Our Ref 25/00339/FULM
7 October 2025

Construction of a solar farm of up to 49.9MW, substation buildings, access tracks, security measures, associated infrastructure and works, and landscape and biodiversity enhancements at Land Surrounding Fallaws of Arbirlot, Arbirlot, Arbroath

Map from c.1900

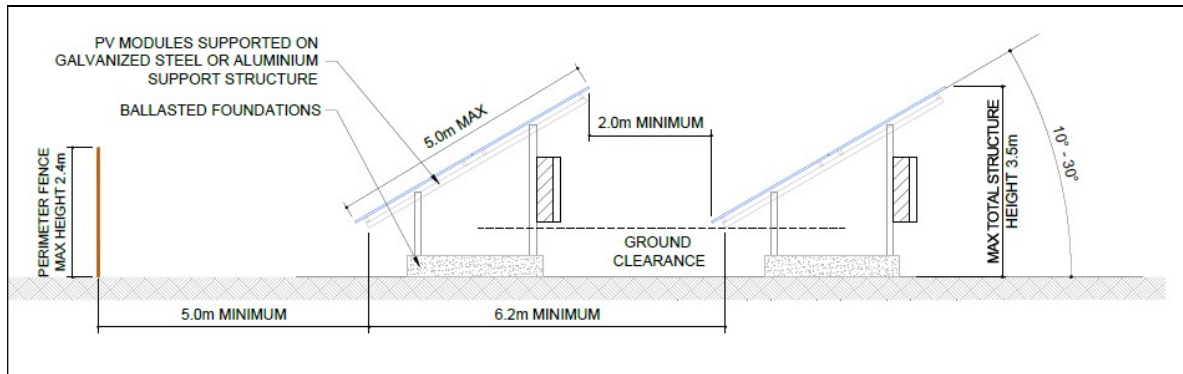
In principle, the Council consider that the site has capacity for solar development, but that, in accordance with the Strategic Landscape Capacity Study for Solar Energy, we would require that the built mass be better visually broken up. Typically, this would be through the reinstatement of historical field boundaries which would be planted with hedges a hedgerow trees, but as discussed, the site does not appear to lend itself to this approach.

The application site is already broken up by the route of overhead lines and an underground pipeline, along with open drains along boundary lines. Furthermore, there are existing access tracks that pass through the site. These existing features either follow the historic field boundaries or effectively supersede them by introducing new constraints.

Nevertheless, in accordance with the spirit of the supplementary guidance, aimed at reducing the visual impact of solar developments by breaking up the overall

mass, more should be made of these existing breaks in terms of landscaping. Simply leaving a clear space around the overhead lines, for example, does little to break up the industrial appearance of the development, and arguably the cumulative impact of both features without mitigation is more significant.

Bonnyknox, Arbirlot (25/00339/FULM) Pending

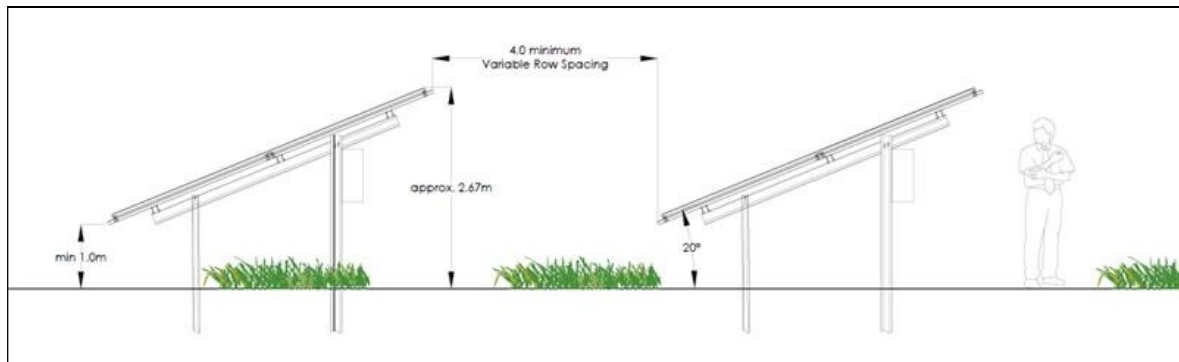
In addition, the Council considers that the proposed height of the panels (3.5m) make it difficult to mitigate adverse effects through tree and hedge planting (on boundaries and within site). The spacing between the rows of panels, at 2m, is also significantly less than other sites that have been proposed in Angus. For context, I have pasted examples from a number of sites below:

- Justification for the size and spacing of the panels themselves, along with the need for so much new access track and so many individual compounds. A reduction in the height of the panels is requested, and removal of unnecessary tracks and compound areas.
- Consideration of reducing panel sizes further where they are closest to the two N-S tracks to reduce the tunnelling effect.
- Clarification of wayleaves and a revised landscaping plan to reflect what can and cannot be delivered due to existing infrastructure.
- Additional landscaping along tracks and in particular watercourses/ditches, with appropriate riparian species to maximise biodiversity gain.
- Assessment of the boundary treatments to reduce harsh visual impact and to ensure permeability for wildlife.
- Woodland planting in line with The Councils Forestry & Woodland Strategy 2024-2034.

Potential for additional landscaping to break up visual mass and enhance biodiversity.

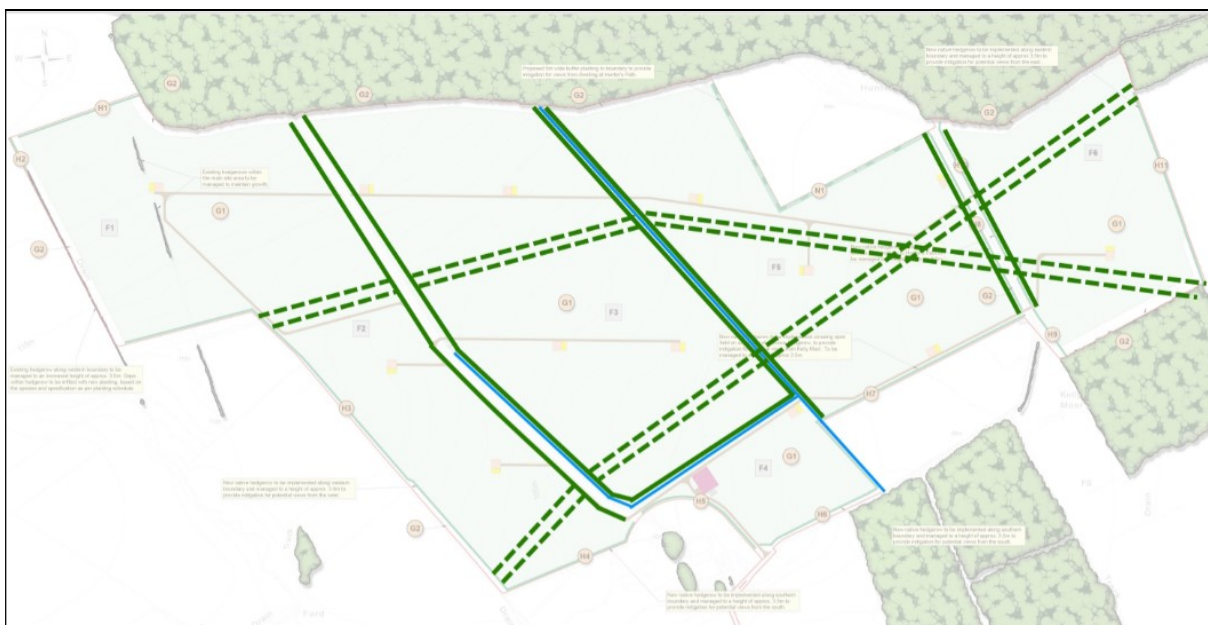
The track to north of Fallaws farm also appears to have an open ditch along the east side. There is also an open ditch that splits the site from north to south, and the two are linked by a ditch to the north of the farm. The eastern ditch appears on site to have a degree of hedgerow and trees along part of its length. This offers an opportunity for riparian planting long the lengths of these ditches to create the breakup of the mass of panels sought by the supplementary guidance, but also to offer the most biodiversity gain by forming wildlife corridors with significant habitat creation. Such planting would also improve the potential enjoyment of the track to the north of Fallaws Farm.

I have also previously noted the uncertainty over the deliverability of landscaping across or in proximity of the routes of existing overhead lines and underground pipeline, and what the implications wayleaves might have on landscape design. The required stand off from these pieces of existing infrastructure may offer an opportunity for additional structural planting to further visually break up the site and also enhance wildlife corridors.

Excerpt from the Forestry & Woodland Strategy 2024-2034

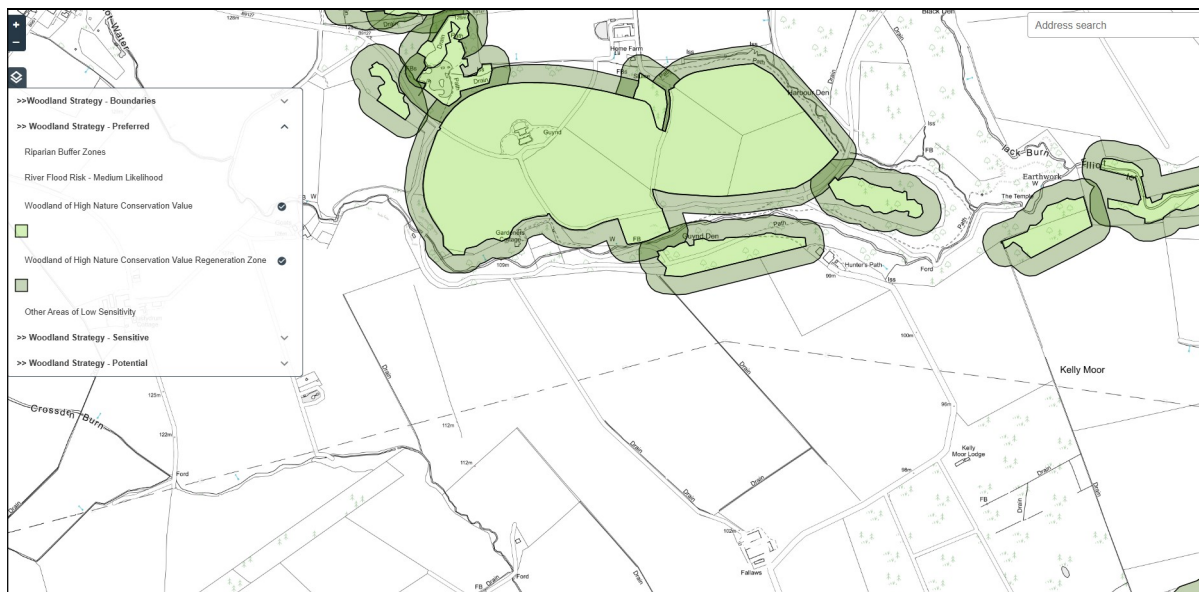
The Councils Forestry & Woodland Strategy 2024-2034 identifies statutory Woodland of High Nature Conservation Value.

The strategy identifies regeneration zones associated with these areas. We would therefore seek that those areas within the site identified in the strategy be proposed for the natural regeneration of woodland.
